# LOP STAKEHOLDER ADVISORY COMMITTEE MEETING

Thursday, February 21, 2008

The following table contains the comments and key issues relating to the Lake Ontario Park Master Plan as raised by the Stakeholder Advisory Committee in the Task Group Meetings held on December 4, 5 and 6 of 2007. At the upcoming Stakeholder Advisory Committee on February 21, 2008, the Lake Ontario Park Master Planning Team will make a presentation of these issues and the proposed responses to each issue. Some of the issues refer to numbered images that follow the table.

**THE BAR, CHERRY BEACH AND NORTH SHORE**  
 draft masterplan

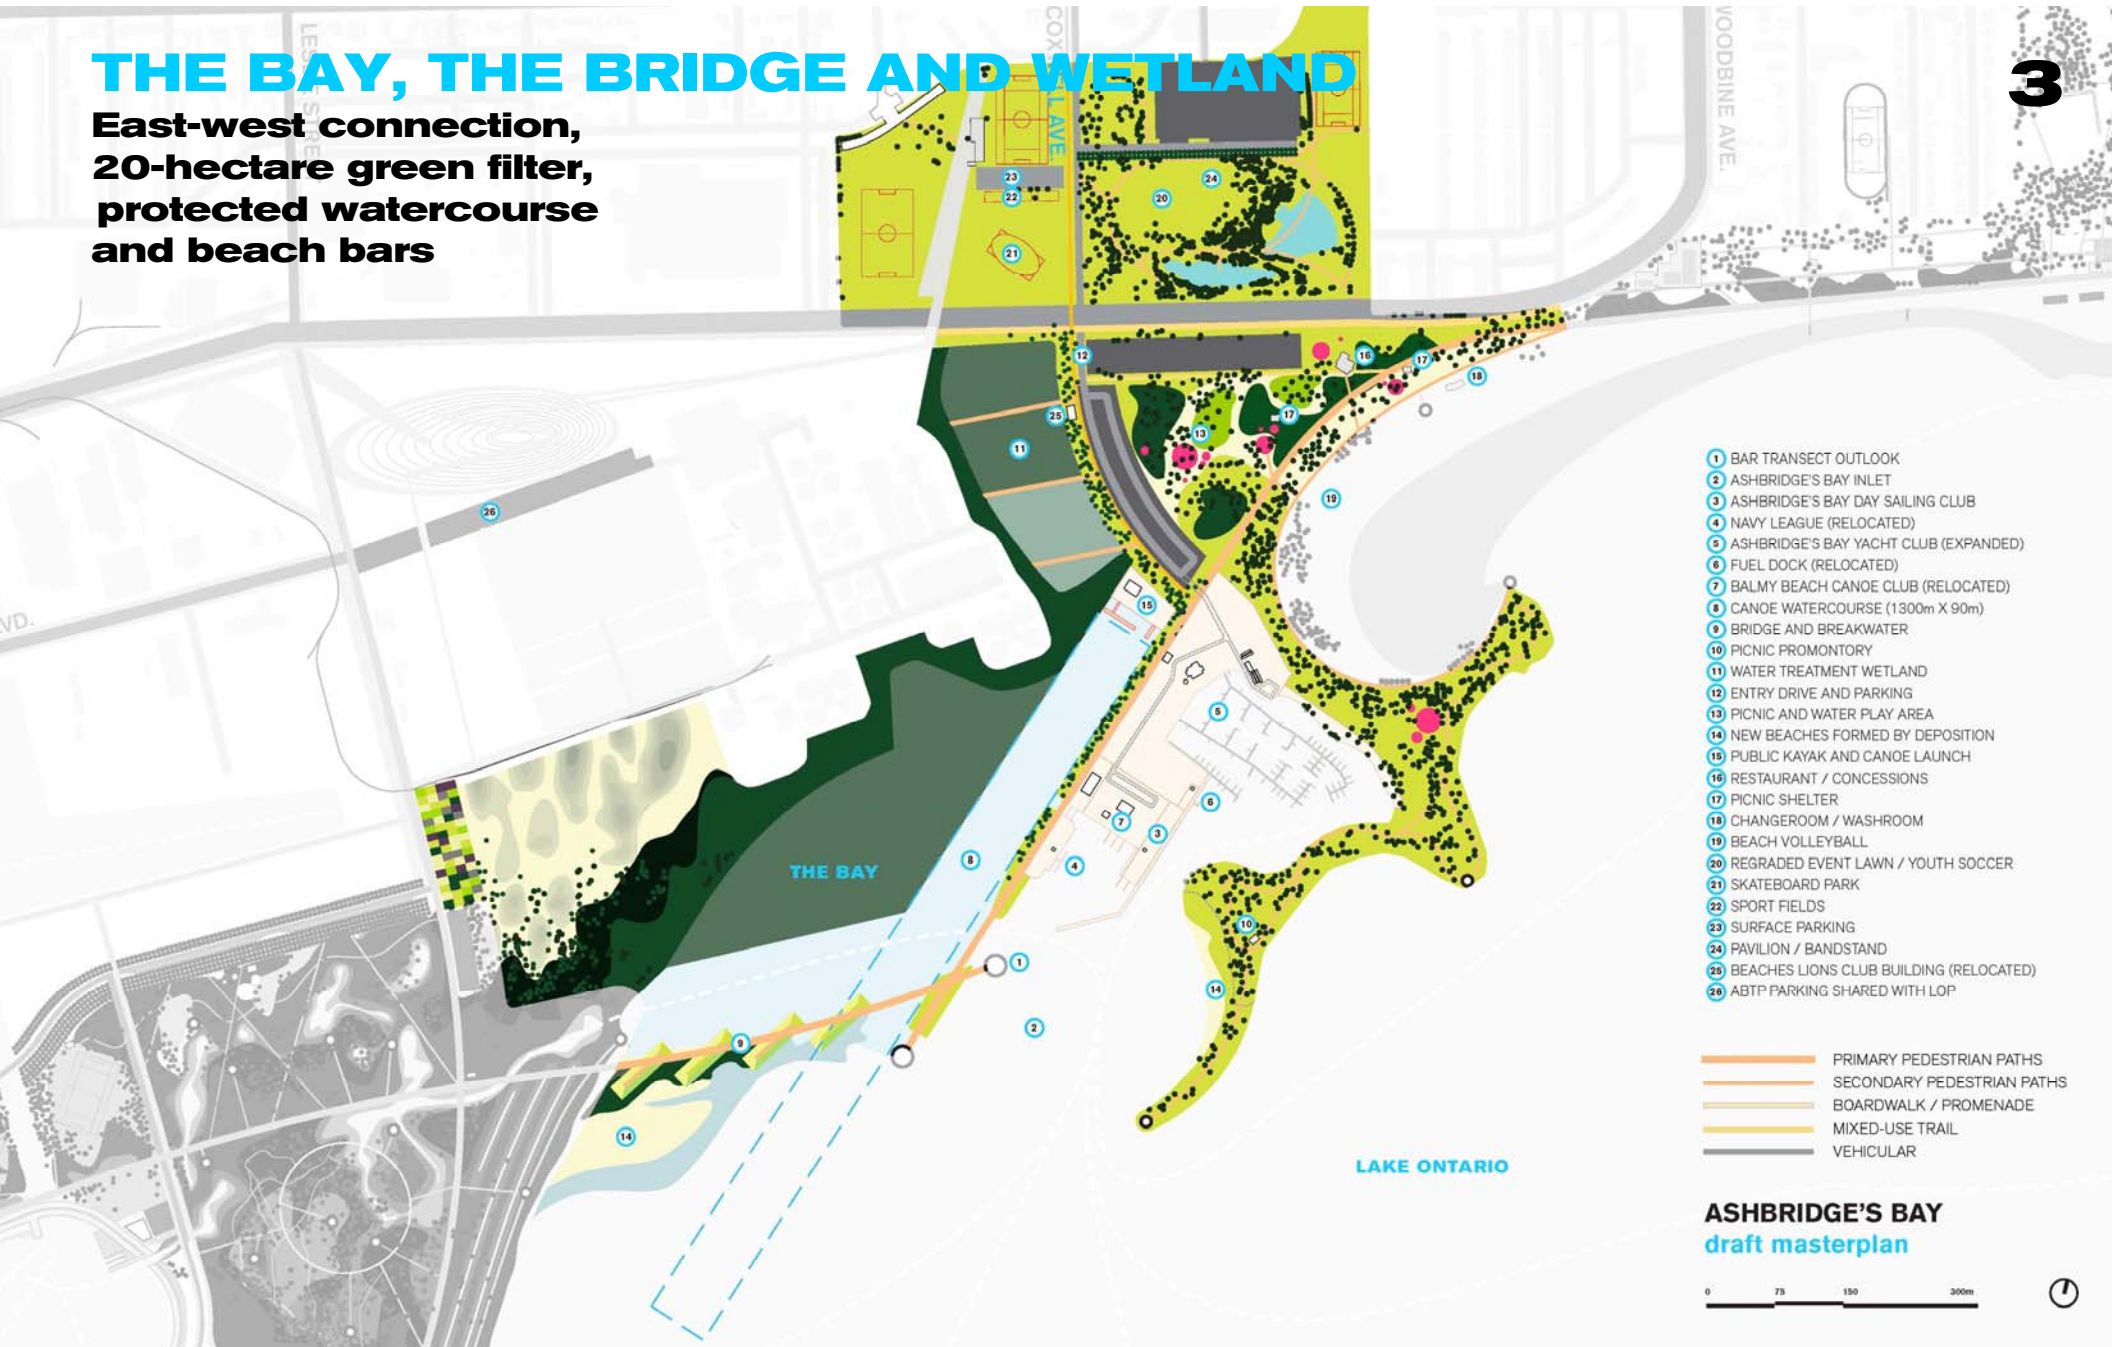
<b>Don Greenway Connection with the Lake</b>	<ul style="list-style-type: none"> <li>• The Design Team noted that the connection between Lake Ontario Park and the Don Greenway is an important ecological link in terms of connecting the park northwards to the Don River system and east along the waterfront to the Base lands and Tommy Thompson Park.</li> <li>• A SAC member suggested that the LOP Master Plan should consider the potential impacts of a regional storm on the Don Greenway and therefore on Lake Ontario Park</li> <li>• Waterfront Toronto staff noted that the orientation and conceptual design of the new Mouth for the Don is being developed through the Lower Don West Class Environmental Assessment (EA), which will consider factors such as the regional storm. The EA is expected to be completed in the spring of 2008.</li> <li>• A SAC member suggested that TEDCO should be assembling land now north of LOP for the Don Greenway.</li> </ul>	<p>The Master Plan recognizes that Lake Ontario Park has a great opportunity to provide a link in a continuous green network that connects the Don River via the Don River Greenway to the Bar and the Base Lands and ultimately Tommy Thompson Park. This important function has been added as an 'organizing idea' for the park (Ref. image 1).</p> <p>Ongoing studies and consultation with Parks, Forestry and Recreation will examine the potential to achieve this green linkage – particularly through the planning of the Bar, while simultaneously creating a publicly accessible landscape with recreational amenities.</p>

<b>Access in Front of North Shore Clubs</b>	<ul style="list-style-type: none"> <li>• The OHSF member suggested that a number of technical issues have not been resolved, including safety, ability of the City to insure docks to which the public have access, fencing and dock design. Crash boats need to be ready for immediate launch in case of an emergency capsizes.</li> <li>• The OHSF would like to meet with Waterfront Toronto, Parks and the Design Team to discuss these issues.</li> <li>• It was suggested that the Design Team look at appropriate examples elsewhere in which clubs interact with the public. Examples cited include the Mississauga Boat Club, Hamilton and Auckland.</li> <li>• It was stressed that the OHSF boat clubs are a venue for the public to learn to sail or row, and therefore provide public access to the water.</li> <li>• It was noted that the City is not pushing for public access in front of large yacht clubs such as the RCYC, Boulevard Club and IYC.</li> <li>• The OHSF is concerned about having a hard surface multi-use trail in front of the clubs.</li> <li>• In response to a question about the origin of the idea of public access, Waterfront Toronto staff indicated that public access to the waterfront was one of the agency’s core principles.</li> <li>• The Design Team was asked to check the amount of space allocated to each club (especially the Outer Harbour Centreboard Club and the Multi-hull Club) to ensure that the Master Plan proposals accurately reflect the amount of land currently leased to each club.</li> <li>• The Design Team stressed that they were not designing the boat clubs or dock configurations in the Master Plan stage. This would be done in the detail design phase of the project. In the detail design, precedents elsewhere would be studied.</li> <li>• It was suggested that the Master Plan should clearly state that the OHSF, Design Team and Parks Department will work together in Phase 1 to design a facility to achieve the desired objectives for each club and the degree to which the public will be able to access the waterfront.</li> <li>• It was also suggested that the Master Plan should not show details of future configuration, docks, etc.</li> </ul>	<p>The Master Plan document will state that the general public’s access to the North Shore will be seasonal and/or limited during the boating season. This will avoid potential conflicts during periods of high activity and will allow the ownership, maintenance and insurance of the docks and ramps to be the responsibility of the North Shore Clubs.</p> <p>The Master Plan Document will state that the OHSF, Design Team, WT and PFR will work together in detail design to achieve the mutually desired boating and park objectives.</p> <p>The Master Plan Document will include an appendix with accurate tables identifying the existing space quantifications and proposed expansion needs/criteria for each club.</p> <p>The Master Plan Document will not include any detail plans for the North Shore clubs and public access. The following drawings will be reference to the clubs and the potential beach extension in the Master Plan document:</p> <ol style="list-style-type: none"> <li>1. The full Master Plan;</li> <li>2. The Detail Plan of the Bar (Ref. image 2);</li> <li>3. The aerial overlay of existing OHSF conditions;</li> <li>4. The aerial overlay of proposed OHSF conditions;</li> </ol>

<b>THE BAR AND THE MARINA PENINSULA (COMMENTS FROM DECEMBER 4, 2007)</b>		
<b>ISSUE</b>	<b>MEETING DISCUSSION</b>	<b>PROPOSED MP RESPONSE</b>
<b>Cherry Beach Woodland Restoration</b>	<ul style="list-style-type: none"> <li>• A concern was raised about the difficulty of meeting canopy targets at Cherry Beach because of the impacts of dogs.</li> <li>• Parks staff indicated that the City was currently reviewing the grandfathering process for existing "off leash" areas including Cherry Beach.</li> <li>• It was suggested that tree planting in the Cherry Beach area consider using indigenous plantings.</li> <li>• The Design Team indicated that any planting programs would include only native plant species, and could consider the use of indigenous species.</li> </ul>	<p><b>DOG WALKING AREAS</b> At the request of the City of Toronto, the Design Team is currently studying alternative locations in Lake Ontario Park for the dog walking area at Cherry Beach, in response to the recent (December 2007) City Off-Leash Policy that recommends against the location of off-leash dog walking areas adjacent to Blue Flag beaches. These studies are forthcoming.</p> <p><b>CHERRY BEACH WOODLAND RESTORATION</b> The Master Plan will identify opportunities to preserve existing stands and support them with infill specimens (for long-term preservation). The Cherry Beach Woodland is a primary opportunity for woodland restoration.</p> <p>With respect to new canopy plantings, the Master Plan will promote the utilization of native, drought-tolerant species to account for future impacts of climate change.</p>

## ASHBRIDGE'S BAY draft masterplan

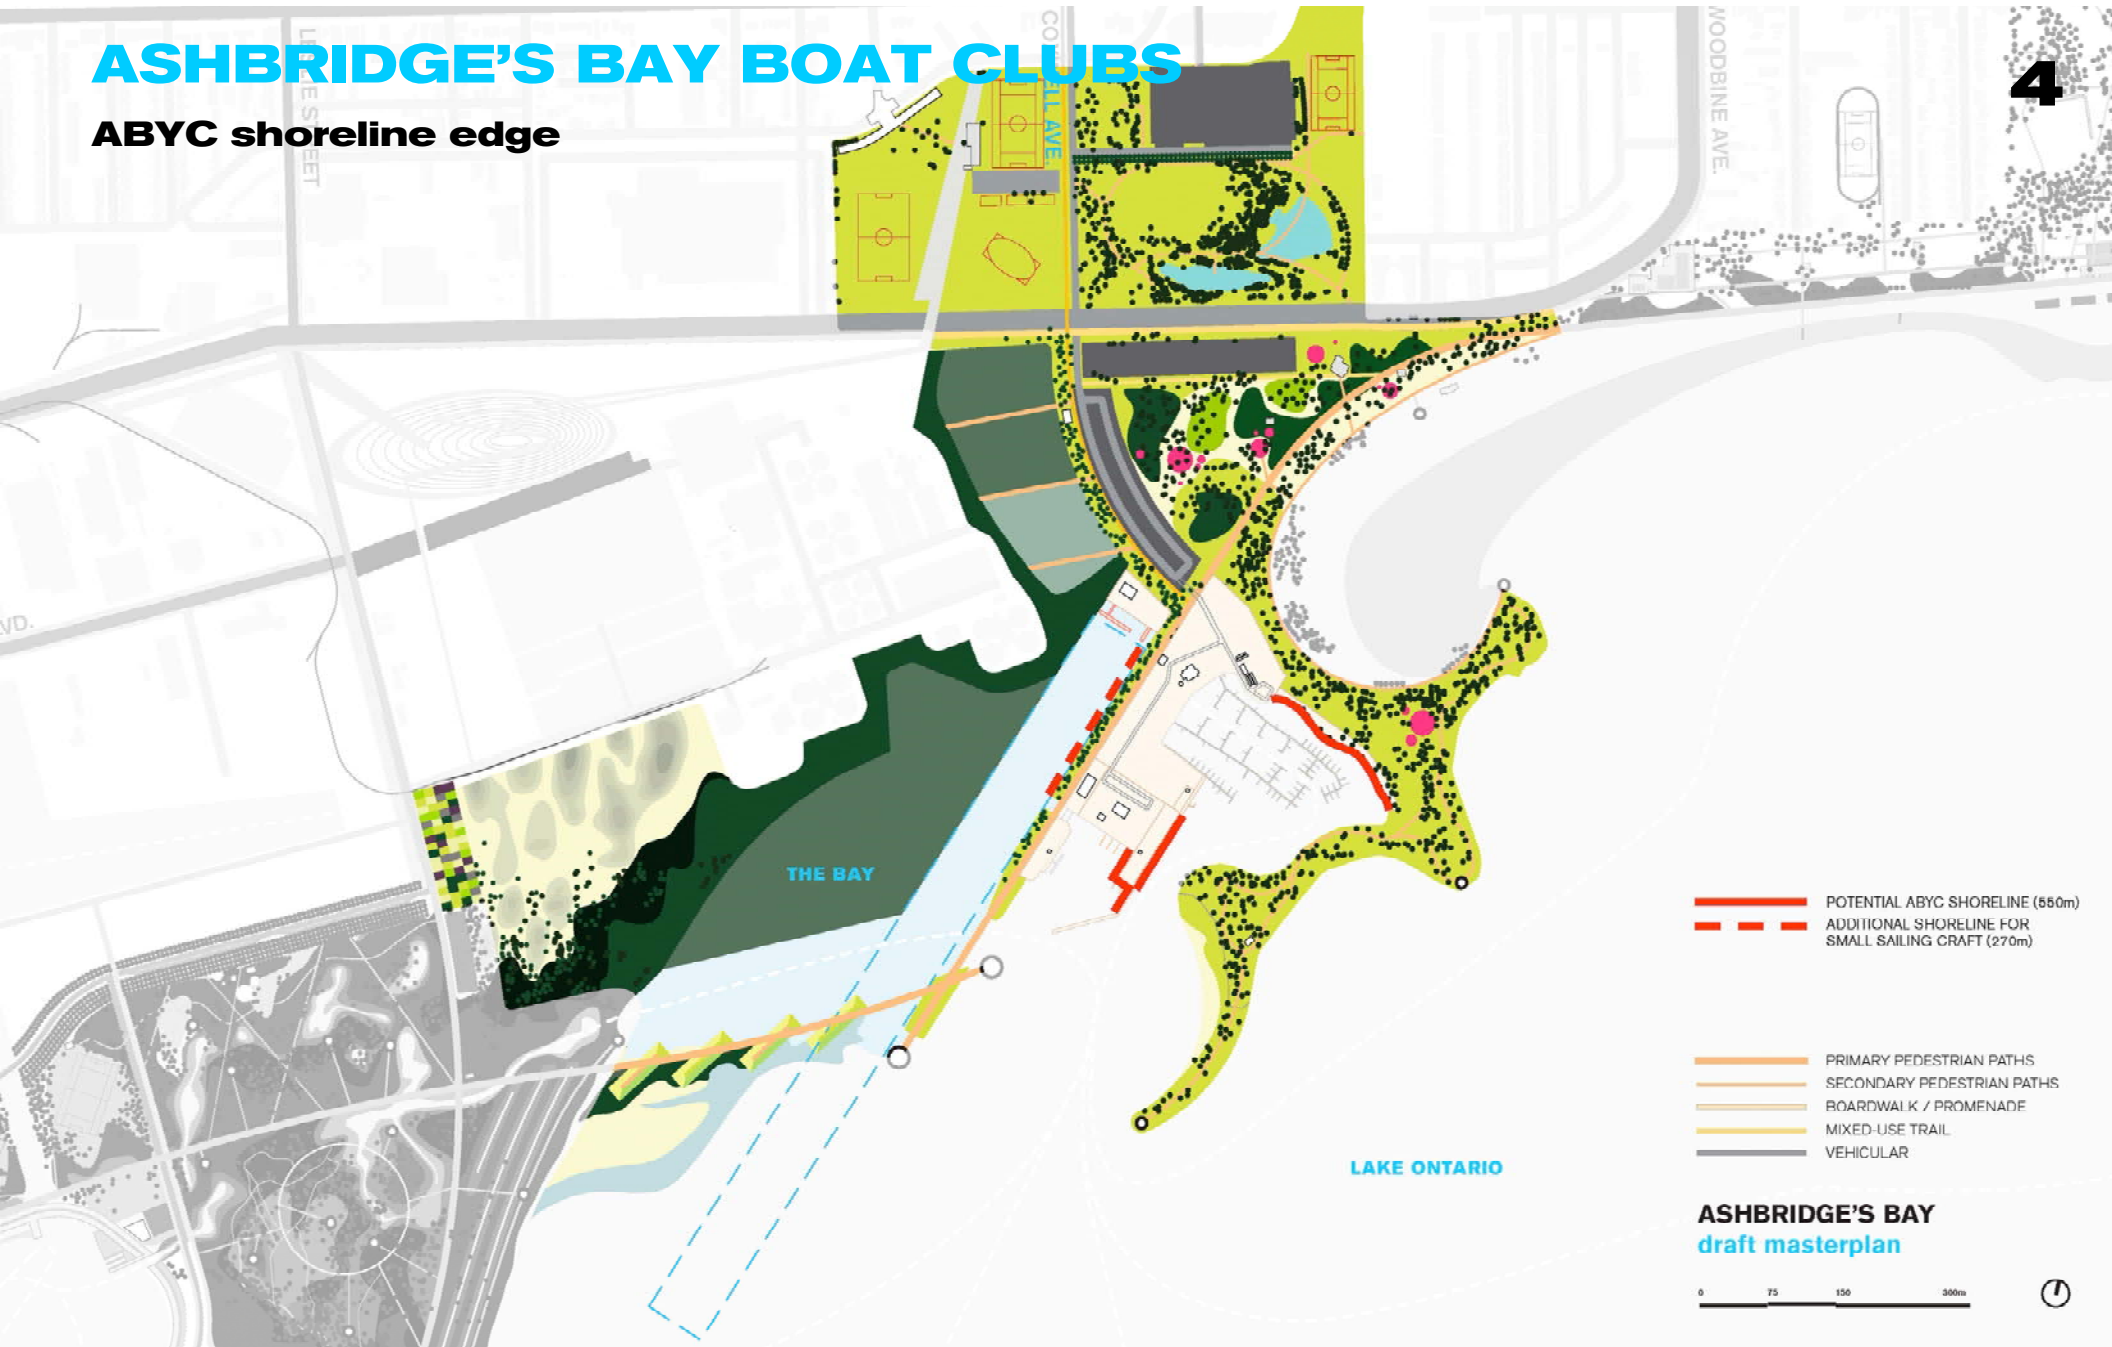
<b>THE BAY (COMMENTS FROM DECEMBER 5, 2007)</b>		
<b>ISSUE</b>	<b>MEETING DISCUSSION</b>	<b>PROPOSED MP RESPONSE</b>
<b>Length of Proposed Watercourse</b>	<ul style="list-style-type: none"> <li>• The Balmy Beach member noted that there is an opportunity to create a longer and more useful watercourse for canoe and kayak training. Ideally this should be 1200 m in length, straight, and 90 m wide.</li> <li>• It was suggested that the rowing clubs would likely support the creation of a longer course.</li> <li>• The existing Master Plan proposal gives about 1300 m of course, but it is not suitable for racing because a) it is not straight and b) it is not 90 m wide.</li> <li>• The Design Team explained that the Ashbridge's Bay Treatment Plant has a lease on the water lots north of the proposed watercourse for future expansion. The current configuration of the watercourse skirts these water lots. It may be 20 years before the expansion is required.</li> <li>• A number of design suggestions were made to allow a longer course to be developed. These included: <ul style="list-style-type: none"> <li>• extending the watercourse southwest under the bridge/breakwater;</li> <li>• extending the transect to the southwest tip of Ashbridge's Bay Park;</li> <li>• moving the bar transect south.</li> </ul> </li> </ul>	<p>The Design Team has studied the spatial feasibility for locating a 1300m x 90m straight watercourse in Ashbridge's Bay (Ref. Image 3).</p> <p>Given the length of the course, it is not possible to fit it solely within the protected waters of the Bay. Approximately 50% of the course would extend beyond the bridge and breakwater into the Lake. The Design Team is researching applications of 'floating breakwaters' – moveable, floating units that absorb wave action and create still water on the landward sides. The physical and financial feasibility of such a solution needs to be studied further, however, it is important to note that the Master Plan does not preclude the ability to establish such a watercourse for canoe and kayak training.</p>

<b>Sides of Watercourse</b>	<ul style="list-style-type: none"> <li>• The Balmy Beach member noted that it was important for the sides of the watercourse to not be vertical walls (i.e., have a sloping edge). This is especially important on the western side of Ashbridge's Bay Park.</li> </ul>	<p>The Master Plan is promoting a green, sloping edge to the watercourse (Ref. Image 3). Further details for this portion of the Bay and Ashbridge's Bay Park will be studied in detail design phases.</p>
<b>Potential Smells from the Wetland</b>	<ul style="list-style-type: none"> <li>• The Lions Club member raised a concern about potential smells from the northerly wetland, especially given changing lake levels and projected lower lake levels.</li> <li>• The Design Team confirmed that there were two possible ways in which the northern wetland could be constructed – terracing of the wetlands or use of floating wetlands. In the latter case, there would be no land showing and no smell. The first option requires decisions on what species of aquatic plants would be used. It was noted that constructed wetlands are often actively managed.</li> <li>• It was confirmed that the northern wetland would receive primarily stormwater, with Combined Sewer Overflows on occasion.</li> <li>• Waterfront Toronto staff confirmed that the original preferred option for the Coatsworth Cut Sewershed Study Class EA involved a southern wetland for water quality improvement. The EA study began well before the Lake Ontario Park Master Plan began. Toronto Water now prefers the northern wetland for water quality improvement because it is easier and cheaper to build, and does not affect the water lots south of the Ashbridge's Bay Treatment Plant, which allow for the future expansion of the plant.</li> </ul>	<p>Two ways to reduce or eliminate smells from constructed wetlands include 1) consistent flow of water, and 2) consistent depth of water. Engineers involved with the Coatsworth Cut EA have assured the Design team that the proposed wetland in Coatsworth Cut will have a consistent flow of water (from urban stormwater sources). Achieving a consistent water depth will be ensured in detail design.</p>

<b>Safety of the Bridge and Breakwater</b>	<ul style="list-style-type: none"> <li>In response to a question about who would be responsible for the safety of users on the bridge and breakwater, the Design Team indicated that it would be City Parks, Recreation and Forestry. The Master Plan document will contain a section on operation and maintenance of the Park.</li> <li>With respect to the question of liability for the City, Parks staff indicated that there is an option of seasonal use only for the bridge and breakwater. Safety stations have been planned.</li> <li>It was suggested that an image of lifesaving equipment be added to some of the renderings or cross-sections in the Master Plan to communicate that safety issues are being addressed.</li> </ul>	<p>Imagery of Buoys and Lifesaving equipment will be added to the Master Plan document, and referenced in the text description of the Bay proposals;</p> <p>In the objectives for the Bay, the Master Plan will promote the incorporation of signage and safety devices into the design of the bridge and breakwaters;</p>

<b>THE BAY (COMMENTS FROM DECEMBER 5, 2007)</b>		
<b>ISSUE</b>	<b>MEETING DISCUSSION</b>	<b>PROPOSED MP RESPONSE</b>
<b>Navigational Safety</b>	<ul style="list-style-type: none"> <li>In response to a question about water depths under the bridge/breakwater, the Design Team confirmed that it was intended to be deep enough to allow dinghies to sail through. The actual depths and profile will be decided in the detail design stage.</li> <li>A member raised a concern about how to keep motorboats out of the proposed watercourse. The Design Team indicated that this would require a combination of signage, policing, enforcement and education. A member suggested the use of a "dog leg" entry".</li> <li>The Balmy Beach SAC member suggested that sailboats from the public launch and beginning sailors could conflict with racing canoes and kayaks. It was noted that historically the canoe club and ABP boating clubs have been able to work out how to co-exist and share the water.</li> <li>It was suggested that it is unclear how the design for the watercourse speaks to the use of the area and that this should be clarified.</li> <li>The Design Team indicated that the text in the Master Plan will describe the uses allowed, signage and other related matters.</li> </ul>	<p>Imagery of Buoys and Lifesaving equipment will be added to the Master Plan Public document, and referenced in text description of the Bay proposals.</p> <p>The usage of the protected watercourse is envisioned for canoes, kayaks and non-motorized 'car-top' sailing craft. The Master Plan is promoting the use of signage and floating markers to communicate allowed uses.</p>

<b>Loss of Shoreline for ABYC</b>	<ul style="list-style-type: none"> <li>The ABYC member indicated that they needed to look at the details to see if the club retains enough shoreline.</li> <li>ABYC needs a specific amount of shoreline to launch both junior club dinghies and small keelboats that are dry sailed and launched with a crane.</li> <li>The ABYC member asked for a meeting with the Design Team to look at the issue.</li> </ul>	<p>The Design Team has measured the existing shoreline edge of ABYC used for launching Junior Club dinghies and small dry sailed keelboats as approximately 470m.</p> <p>In the Master Plan Proposal, the Design Team has identified the potential for 550m of shoreline edge (Ref. Image 4). Achieving an appropriate length of shoreline edge will be ensured in detail design.</p>
<b>Wave Action in the Balmy Beach/Navy League/ABYC Junior Club Embayment</b>	<ul style="list-style-type: none"> <li>Concern was raised about the ability of the deflector arms or "hooks" as proposed to protect the embayment from wave action. Because of the nature of the uses here (launching canoes and dinghies), flat water is needed.</li> <li>A similar concern was raised about the new entrance to ABYC.</li> <li>The Design Team confirmed that the Balmy Beach/Navy League/ABYC Junior Club Embayment would allow small motorboats (e.g., crash boats and coach boats) but was intended as a place for craft that need protected waters.</li> </ul>	<p>The Master Plan will note that the size, shape, location and orientation of the deflector arms will be tested in 3D modelling in the detail design stage. The design will need to demonstrate that the deflector arms accomplish what they are intended to do and are not a problem for navigation and sedimentation.</p>
